STAFF REPORT
COMMUNITY DEVELOPMENT DEPARTMENT

HEARING DATE: 12/22/2020
 TO: Mayor & City Council
 FROM: Joe Dodson, Associate Planner
 208-884-5533
 SUBJECT: H-2020-0104
 Wadsworth Meridian Subdivision
 LOCATION: The site is located at 3085 E. Ustick Road, at the southwest corner of S. Eagle Road and E. Ustick Road, in the NE ¼ of the NE ¼ of Section 5, Township 3N., Range 1E.

Request for Preliminary Plat approval consisting of five (5) commercial building lots on 3.29 acres in the C-G zoning district for ownership purposes, by Wadsworth Development.

Preliminary Plat
1 of 1

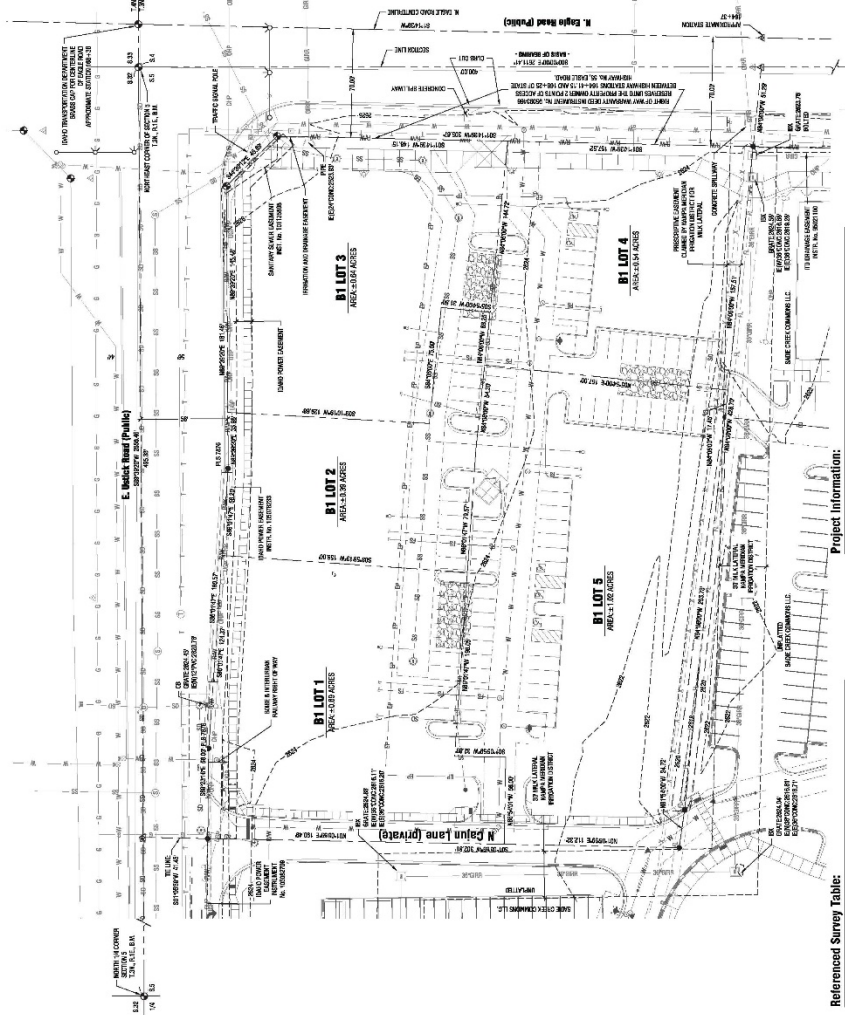
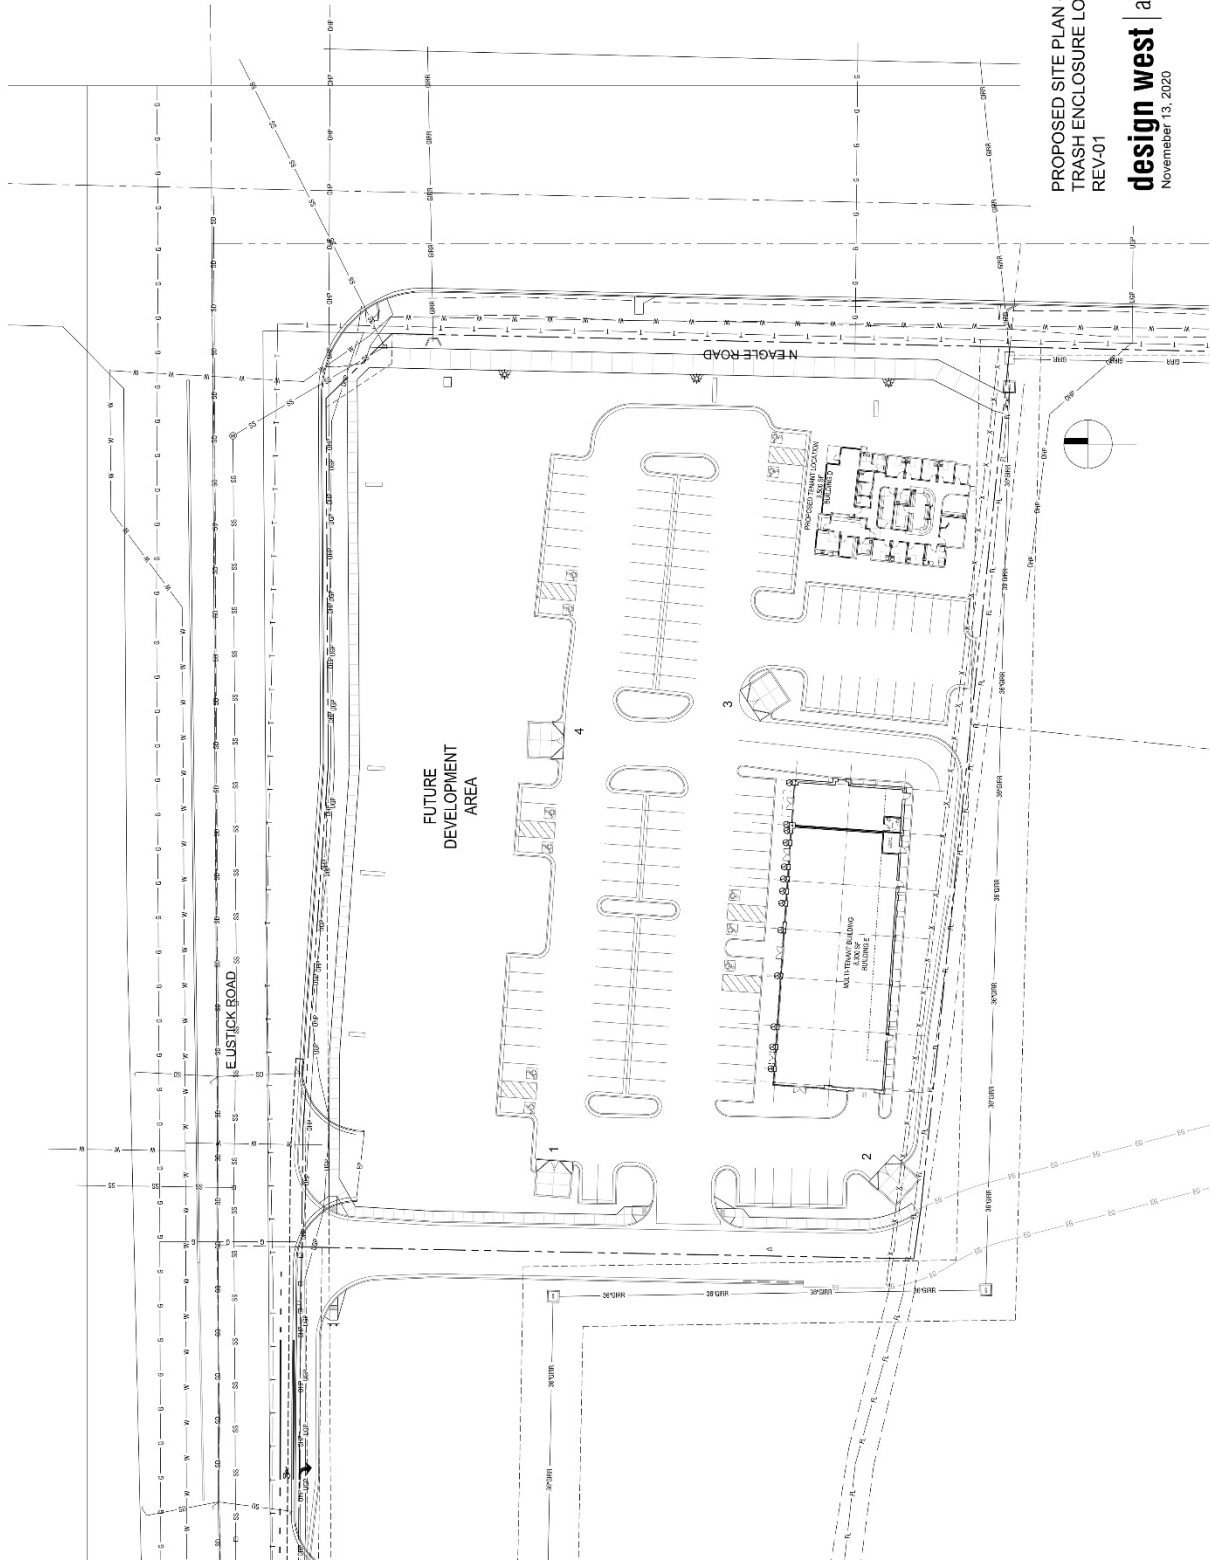
1. With the final plat submittal, the preliminary plat included in Section VII.A, dated September 28, 2020, shall be revised as follows:
 - a. Add a plat note prohibiting direct lot access to E. Ustick Road and N. Eagle Road.

- b. Add a plat note noting the existing cross-access agreement with the adjacent commercial properties (Parcel numbers S1105110110 & S1105110120) to include the recorded instrument number (Inst. #106169335).

- c. Revise plat note #11 to include the record instrument number for the Covenants, Conditions, and Restrictions (Inst. #2020-075457).
 - d. Remove the name of the shared driveway shown on the plat as N. Cajun Lane—this is not a named street in this location.

- e. Graphically depict the required landscape buffers along E. Ustick Road and N. Eagle Road on the plat per UDC 11-3B-7C.2.
2. The landscape plan included in Section VII.C, dated October 9, 2020, is approved as submitted.
